Irban Design Commission ity of Madison, WI Project Name:		St. Paul's University Catholic Center Madison, Wisconsin	
	Project No.:	27043.00 File No.(s): 21.3	
	Date:	October 7, 2014

From:	Randall L. Milbrath, AIA
Subject:	UDC Review Comments from May 16, 2012 Meeting
Copies to:	Fr. Eric Nielsen, Robert Shipley, Ron Trachtenberg, Lee Madden – St Paul UCC File

Following are the design team's revisions pursuant to UDC comments provided May 16, 2012:

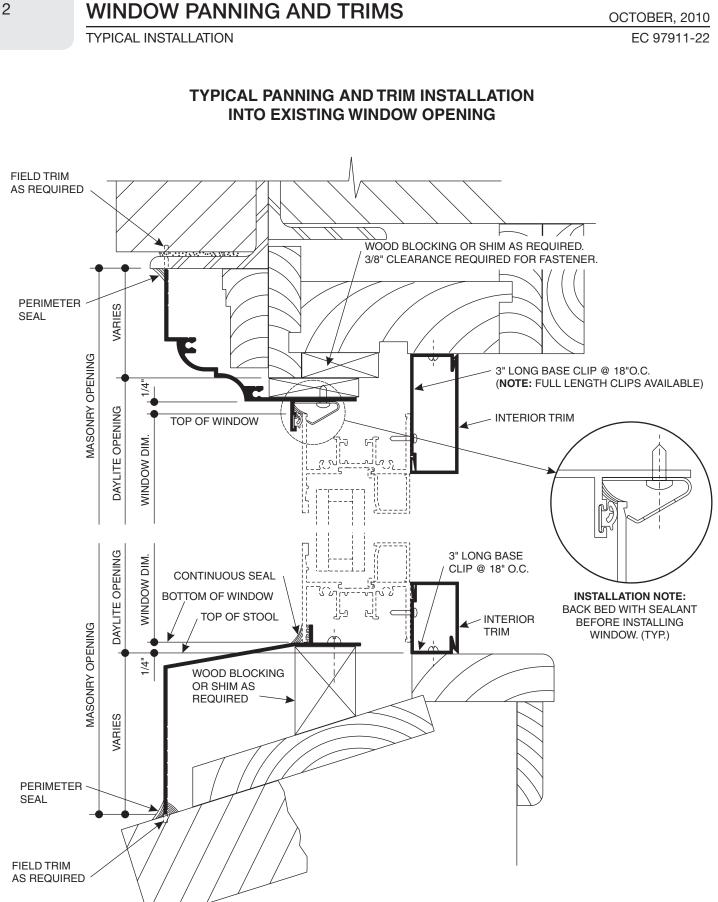
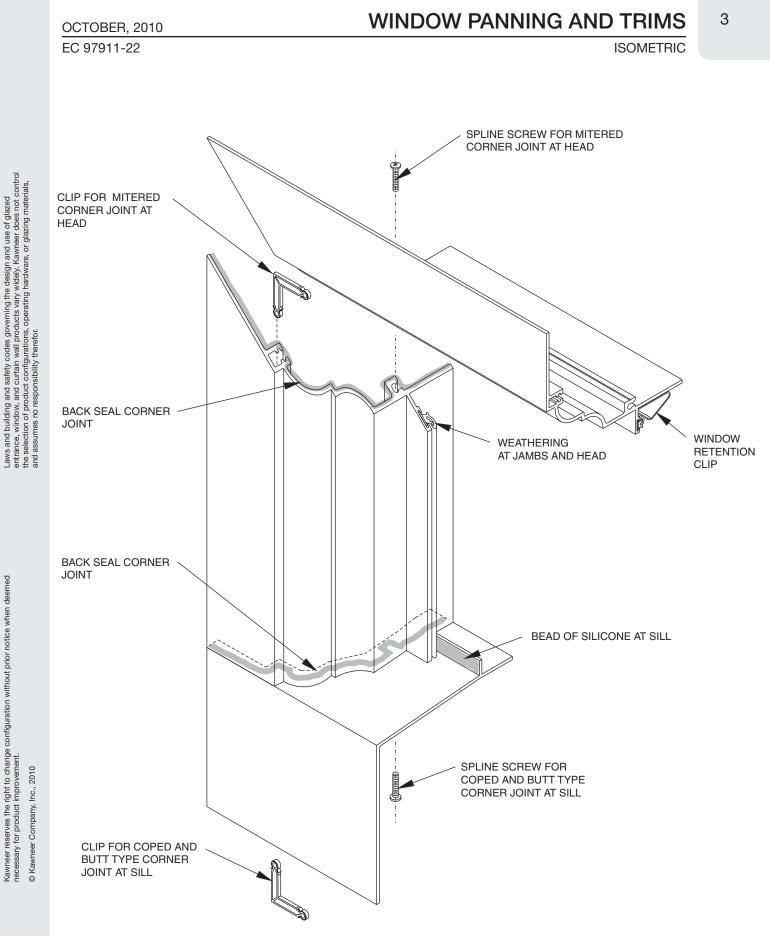
- Masonry returns will be a minimum of 4" to face of aluminum storefront system. Typically, returns will be more substantial than 4". Window frames will be a historic frame profile and will be placed a minimum of 4" back from the exterior face of the exterior veneer. See attached drawing plate showing typical window jamb and perspective window image.

CHAPEL WINDOWS AT BALCONY

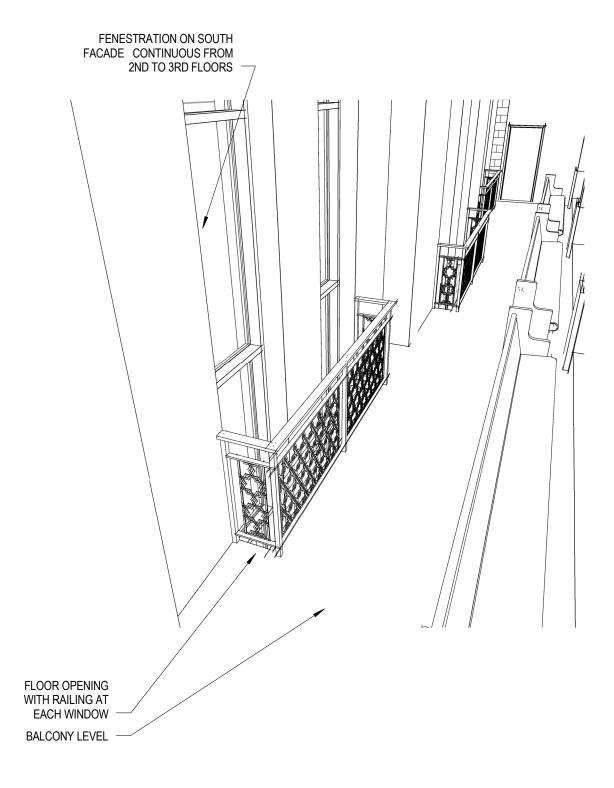
- 8. The balcony seating will be recessed away from the windows to allow full height glass and increase natural daylight to the chapel. The balcony seating has been revised to eliminate the multi-tire seating at the sides and locate the access way adjacent to the exterior wall. This allows the floor to be voided at the full height windows and maintain glass for their full height, eliminating any spandrel panels in the east arched windows. See attached drawing plate showing the window/railing perspective at the upper level of the chapel.

CHAPEL SECTION - VIEW WEST 1" = 20'-0"

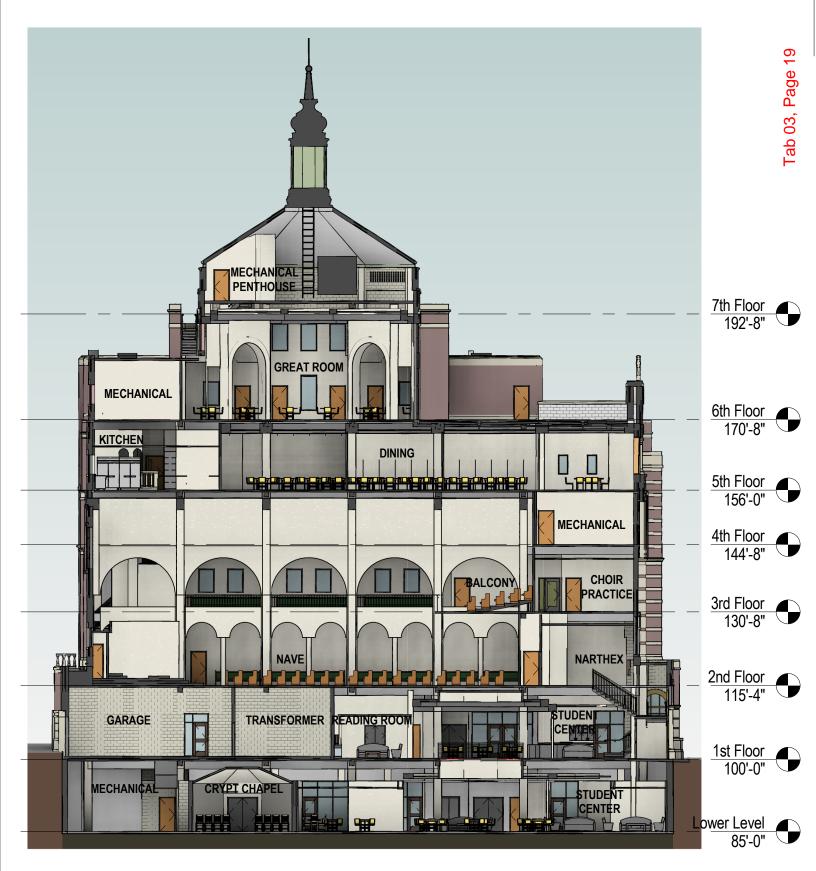
- 3. Sections: A revised building section is provided with the re-submittal drawings. General building heights, massing and circulation paths have remained similar to the previously submitted design.
- 4. Site Plan: Current civil drawings (90% CD level) are included with the re-submittal drawings. General building footprint, grading and utilities have remained similar to the previously submitted design.

South Elevation 1" = 20'-0"

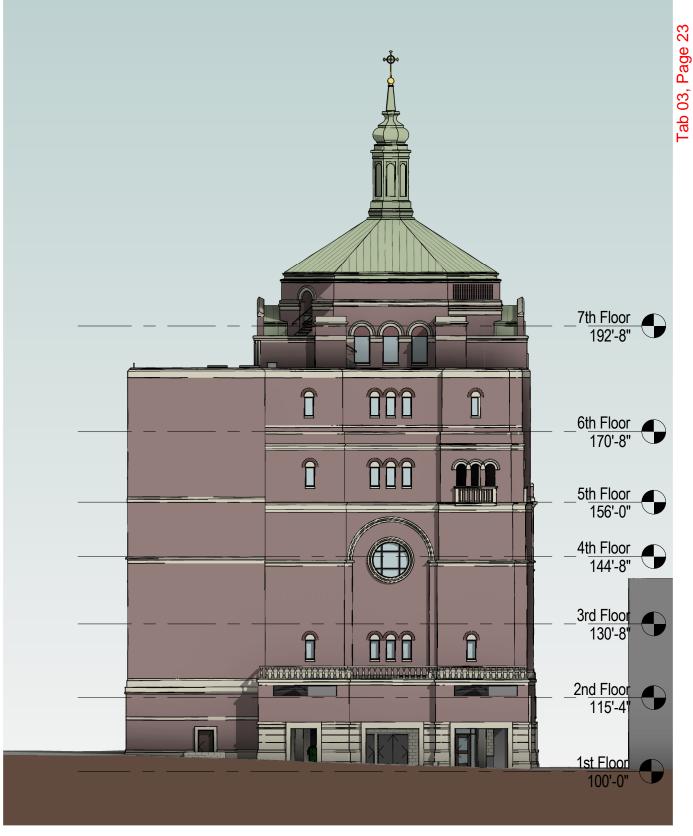
- c. South Elevation: Window locations have adjusted to accommodate interior programmatic changes, but in general maintain the previous configuration. An additional garage opening has been provided and the trash room opening reduced in size. A stone balustrade has been added to the low roof area adjacent to the Pres House Apartments to minimize building scale and the 4th floor roof garden has been eliminated as previously requested. The rose window has increased in diameter by 1' to provide additional natural light to the chapel.
